TO: Development Review Board
FROM: Scott Gustin 
DATE: November 18, 2014
RE: 15-0549SP; 316-322 Flynn Avenue

Request: Sketch Plan review to remove existing building and construct new mixed use building for deli, office space, and nine residential units.

PINE & FLYNN DEVELOPMENT | SKETCH PLAN REVIEW

WEST ELEVATION | PINE STREET

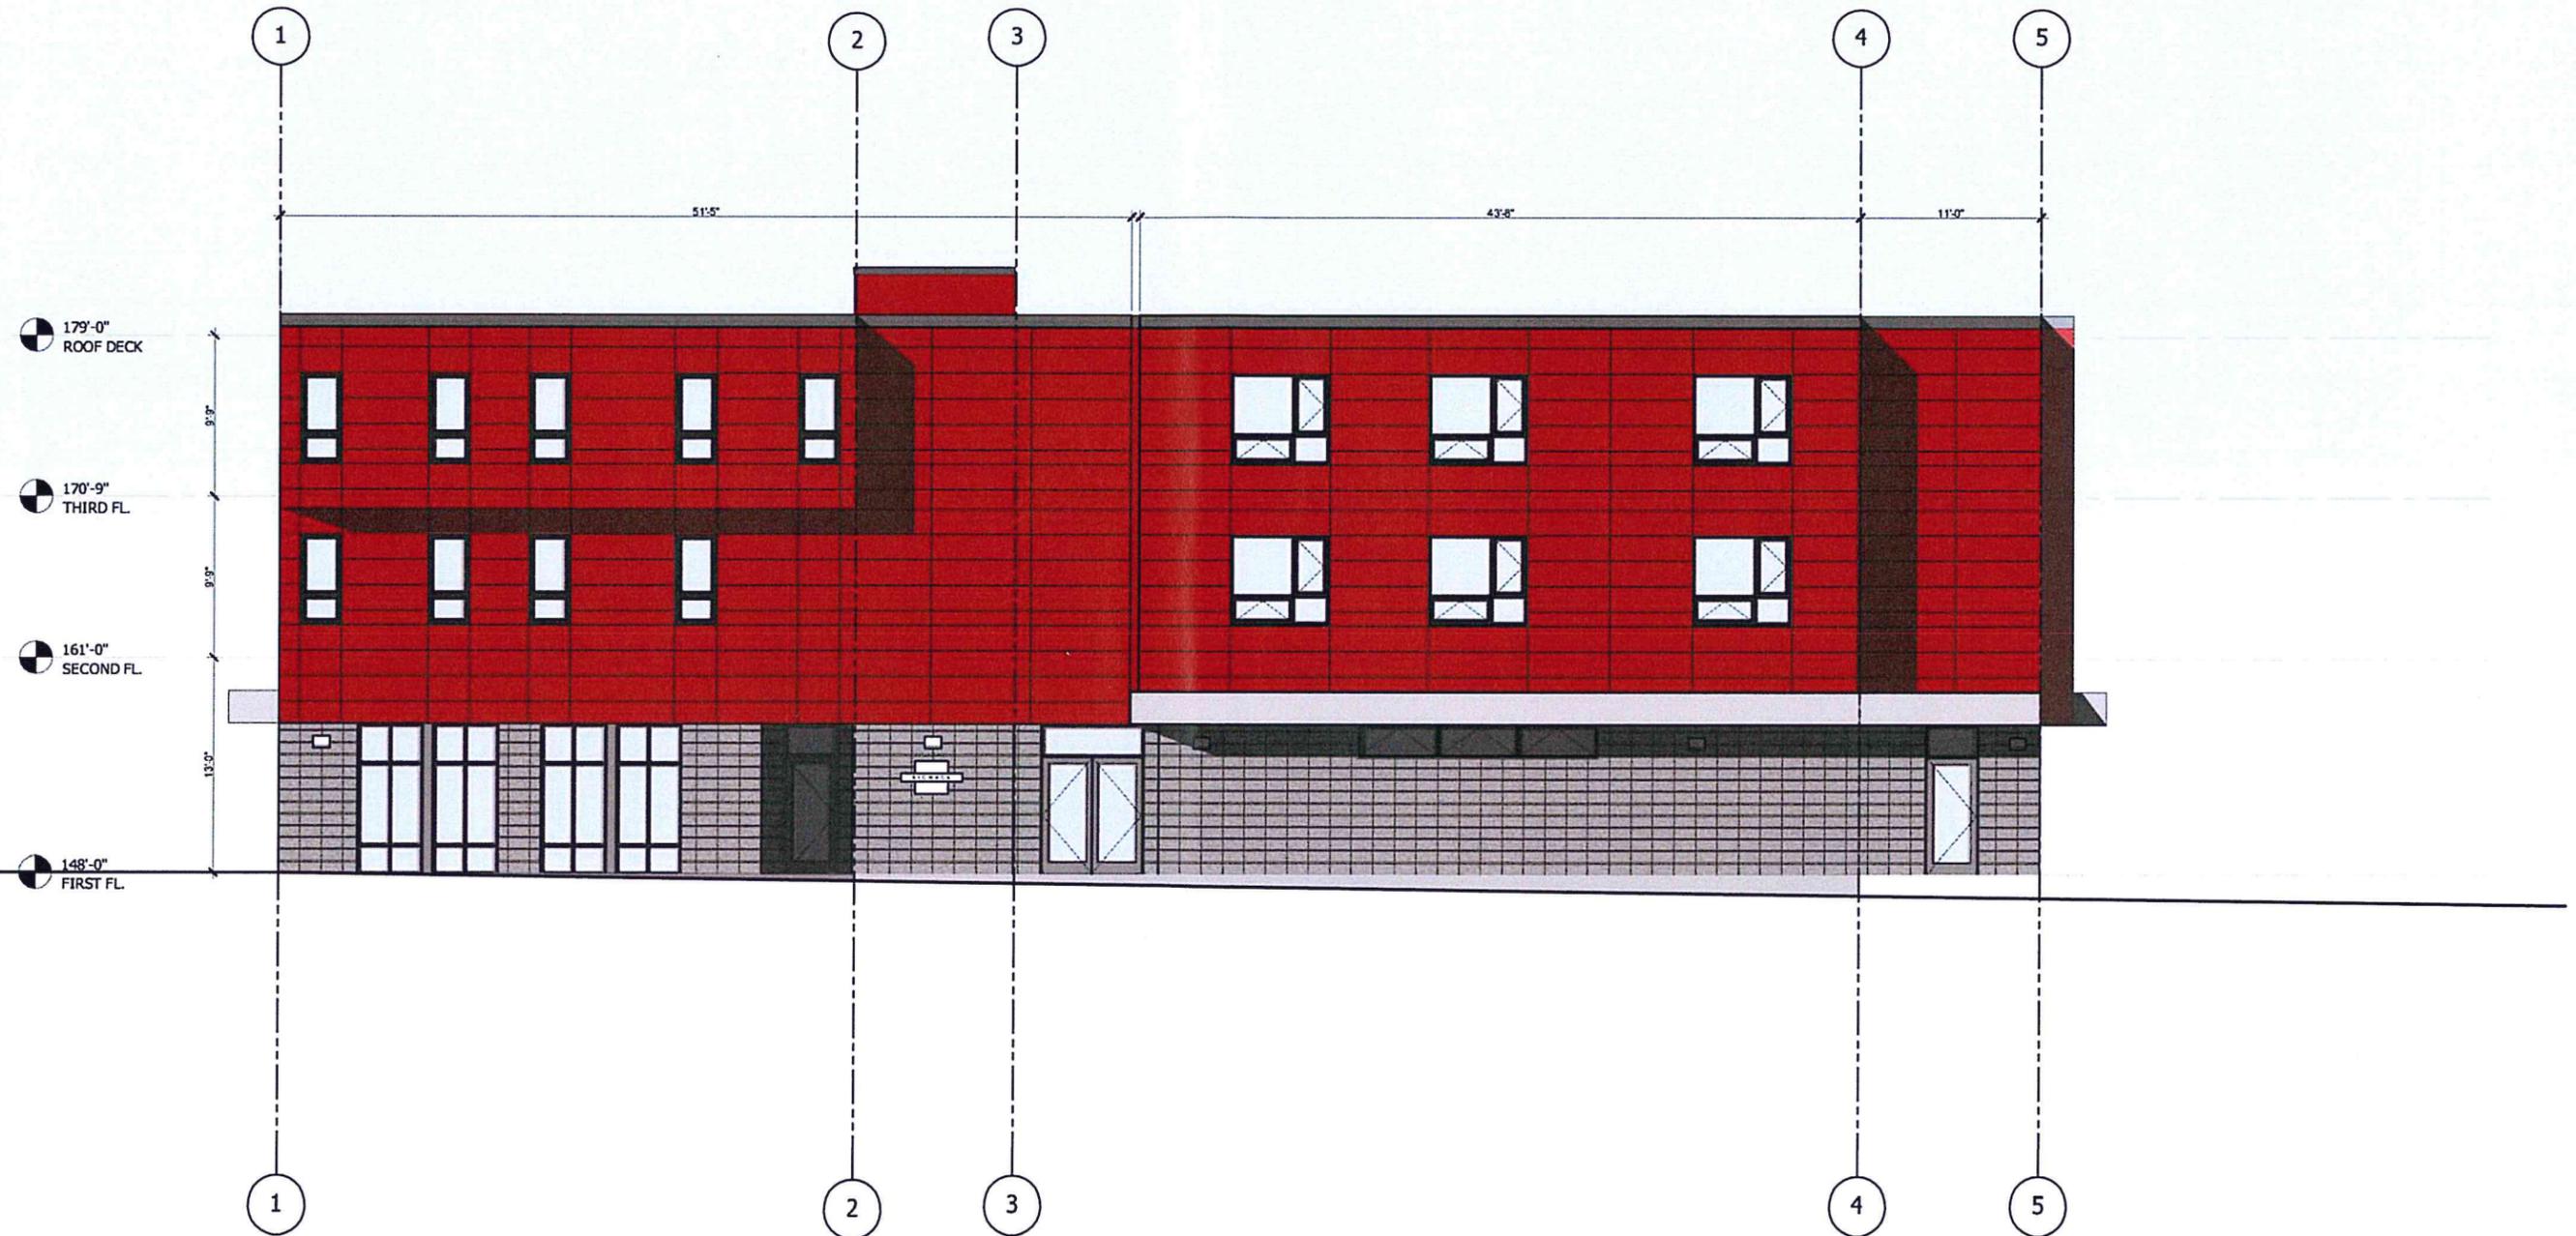
Potential signage is depicted on the wrap-around canopy. The canopy will double as a sign band. The signs depicted thereon are conceptually acceptable. The "ALVANOS 2015" sign at the top of the elevator tower is too tall and cannot be permitted. The height limit is 14' or the ceiling height of the first floor, whichever is lower.
